Proposal #12: 2290-24-70
Caledonia – Oak Creek
Linwood Rd to E Oakwood Rd
STH 38
Racine County

This is Addendum No. 02, which provides for the following:

ADDENDUM NO. 02

2290-24-70

Addendum No. 02
 ID 2290-24-70
 Revised Sheet 38
 April 28, 2023

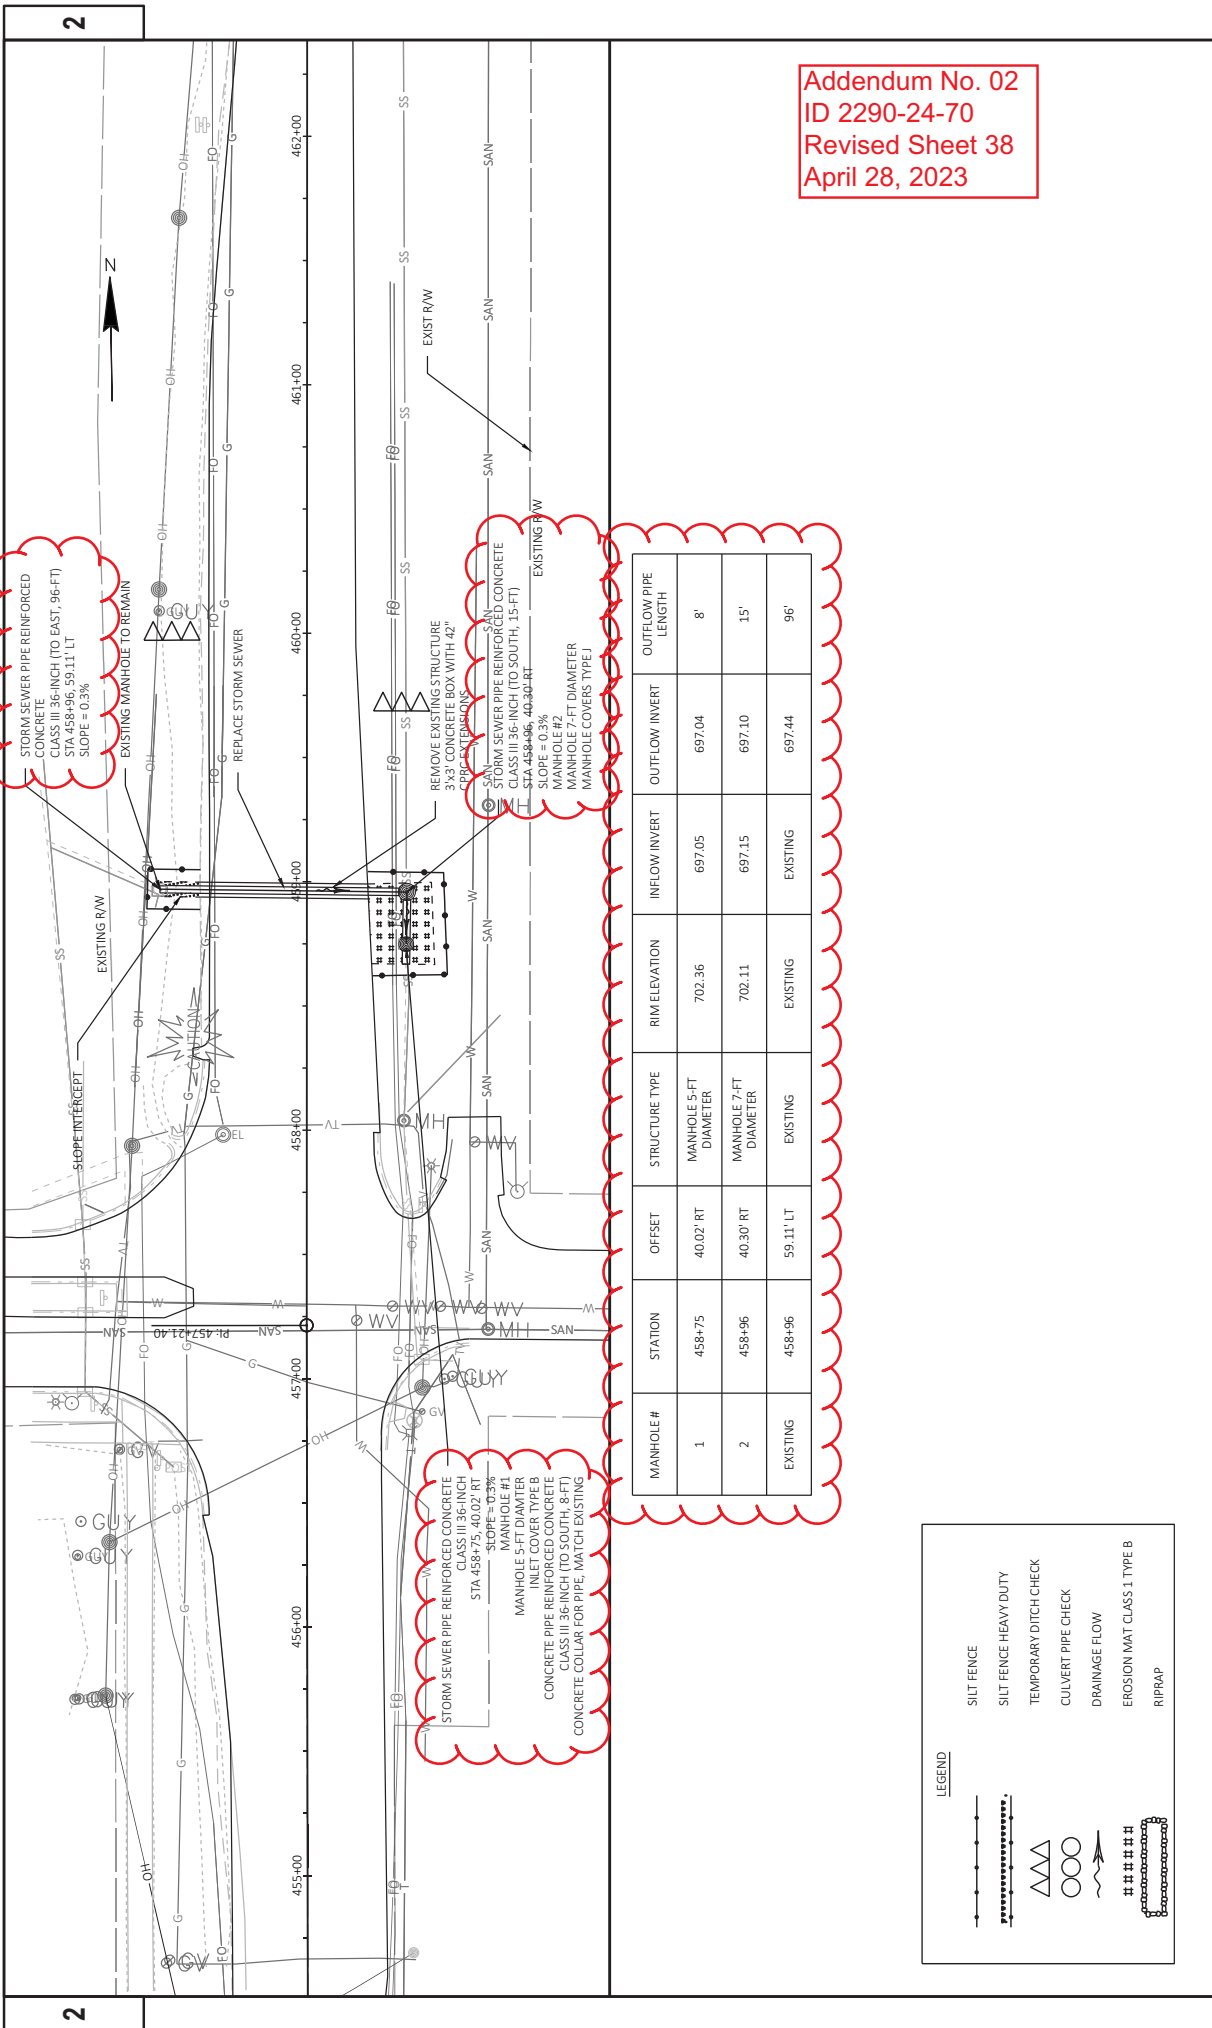
Revised Plan Sheets	
Plan Sheet	Plan Sheet Title (brief description of changes to sheet)
38	Revised/clarified storm sewer information

STORM SEWER PIPE REINFORCED CONCRETE CLASS III 36-INCH (TO EAST, 96-FT) STA 458+96, 59.11' LT SLOPE = 0.3%
 EXISTING MANHOLE TO REMAIN

REMOVE EXISTING STRUCTURE CONCRETE COLLAR WITH 42" SANITARY MANHOLE
 STORM SEWER PIPE REINFORCED CONCRETE CLASS III 36-INCH (TO SOUTH, 15-FT) STA 458+96, 40.30' RT SLOPE = 0.3%
 MANHOLE #2
 MANHOLE 7-FT DIAMETER
 MANHOLE COVERS TYPE J

STORM SEWER PIPE REINFORCED CONCRETE CLASS III 36-INCH (TO EAST, 96-FT) STA 458+75, 40.02' RT SLOPE = 0.3%
 MANHOLE #1
 INLET COVER TYPE B
 CONCRETE PIPE REINFORCED CONCRETE CLASS III 36-INCH (TO SOUTH, 8-FT) STA 458+75, 40.02' RT SLOPE = 0.3%
 CONCRETE COLLAR FOR PIPE, MATCH EXISTING
